Equity Response 2017-0117 to Staff's January 12th Comments

WESTWOOD SHOPPING CENTER

SKETCH PLAN

PROPERTY DEDICATION EXHIBIT

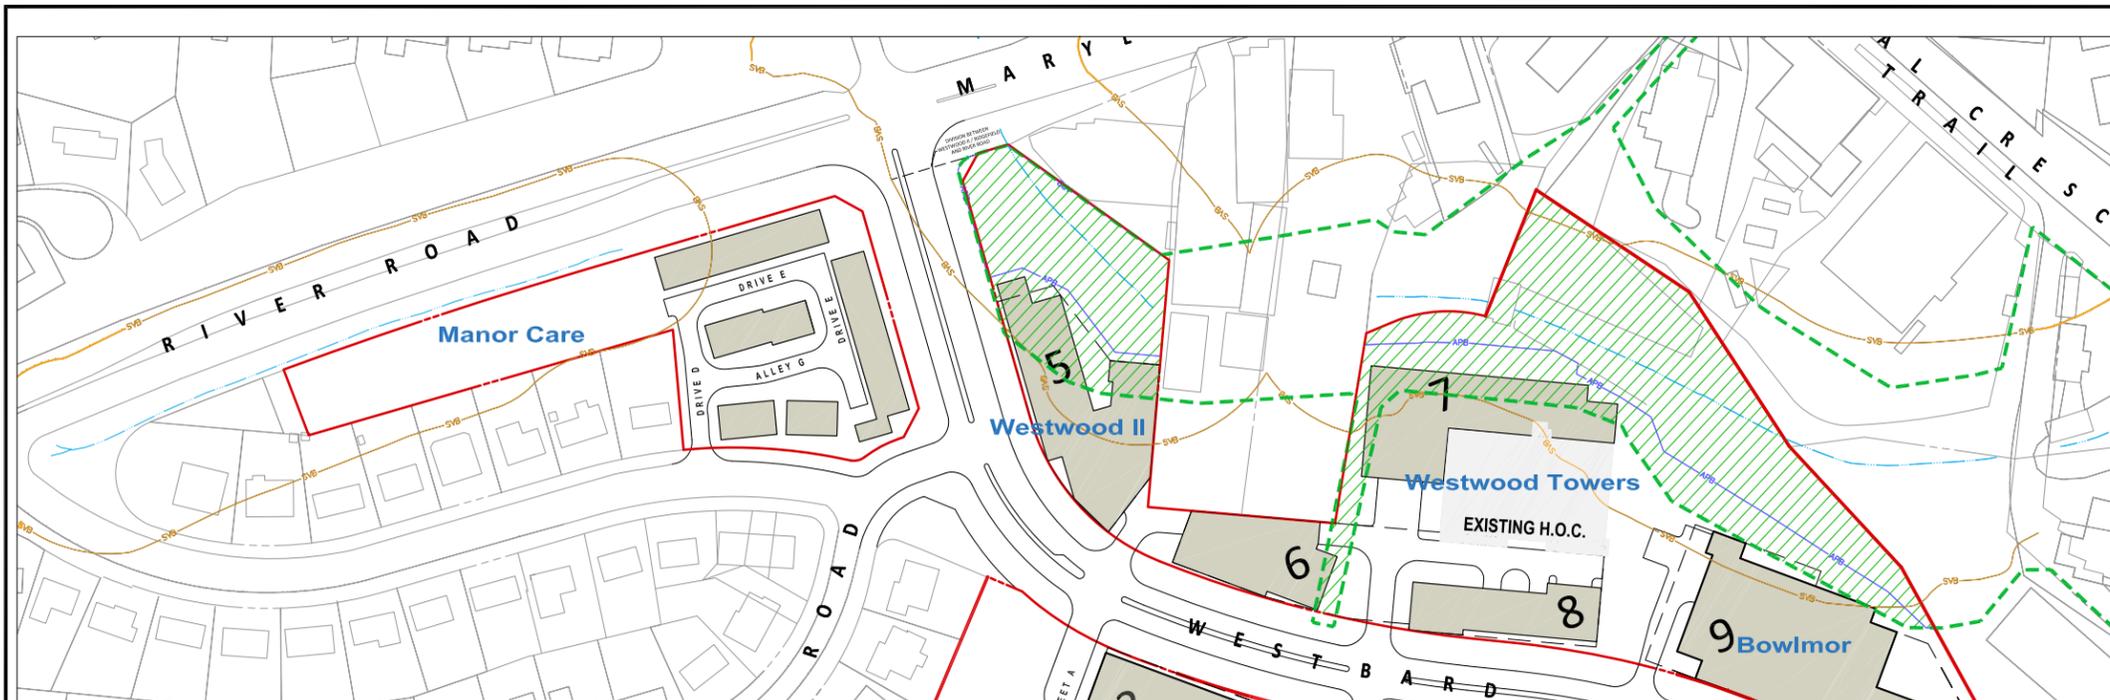
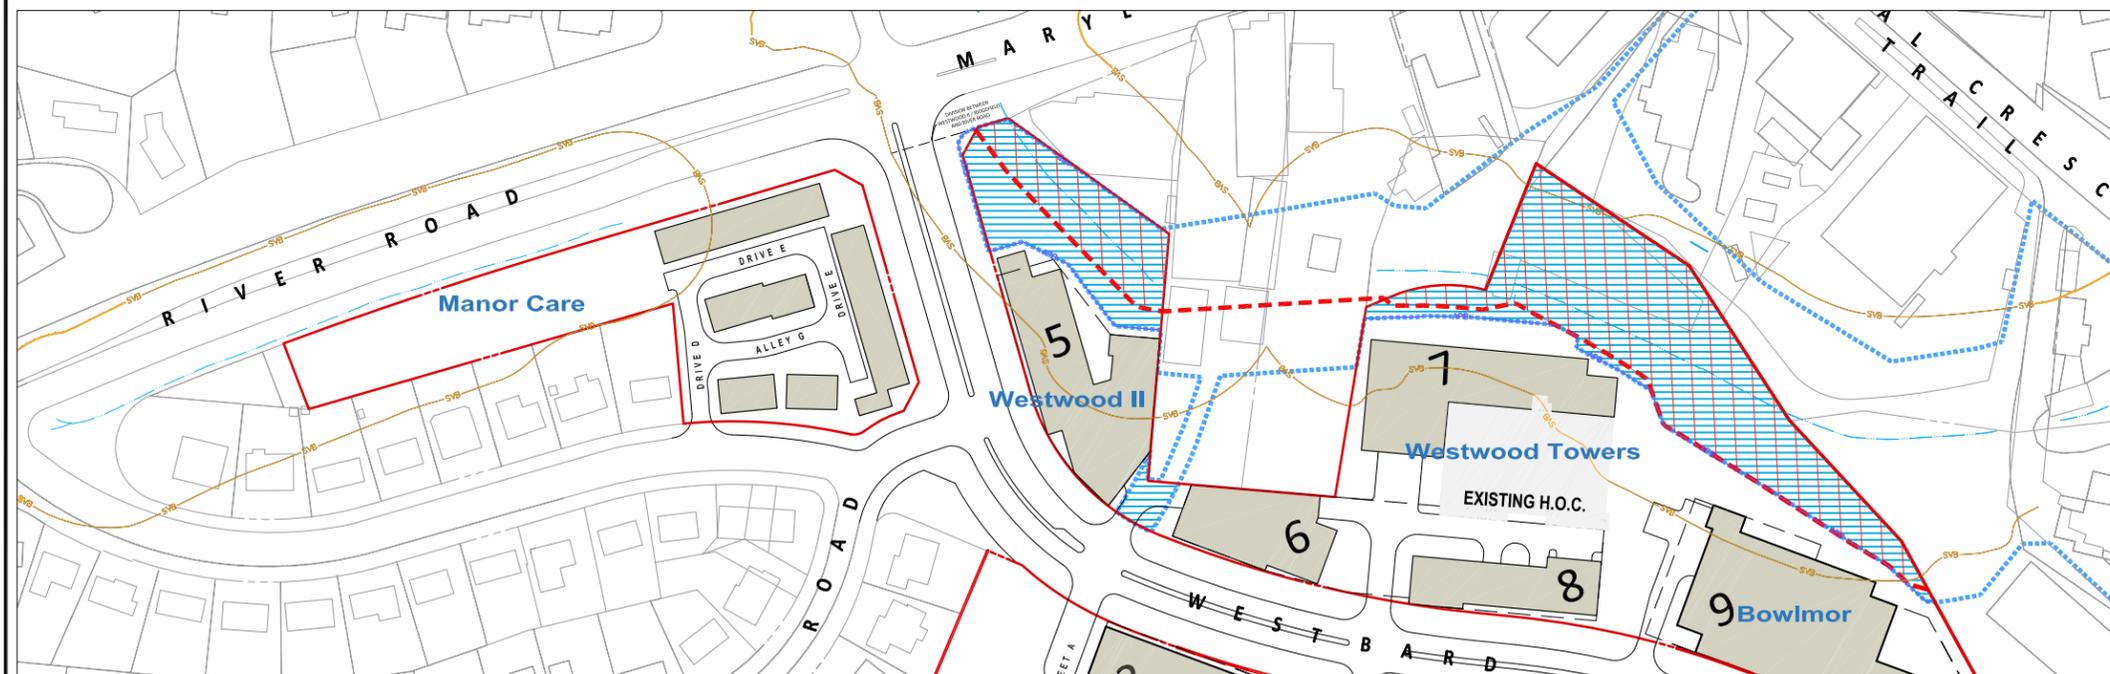
<p>9. Provide a breakdown per site and overall which compares the square footage of Staff’s proposed dedication, Applicants proposed dedication, existing SVB and existing/proposed SVB encroachments areas.</p>	<p>9. See new exhibit SK17 included with this submission.</p>
<p>10. APB (Applicant’s Proposed Boundary) should be changed to APD (Applicant’s Proposed Dedication) on all sheets.</p>	<p>10. As we discussed, Equity One is proposing a modification to the buffer, and therefore has retained the existing language of the plan. Equity One understands that the modified buffer line also represents a dedication line.</p>
<p>11. The Willett Branch is hatched as open space but not included in the open space calculation in the chart on SK3. It appears</p>	<p>11. The Willett Branch open space will be off-site after dedication. Therefore, a new color for off-site open space has</p>
